# Service Bulletin

16-021

## **Product Update: Roof Molding**

Supersedes 16-021, dated March 5, 2016 to revise the information highlighted in yellow

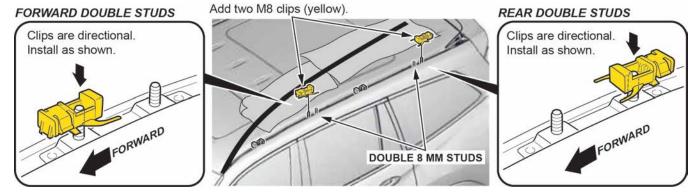
Replace the existing roof molding clips and add additional clips.

4. Install the front M8 roof clip (yellow color) on the first stud of the double 8 mm stud as shown, then install the second M8 roof clip on the second double 8 mm stud.

NOTE: Make sure the clips are installed facing the correct direction.
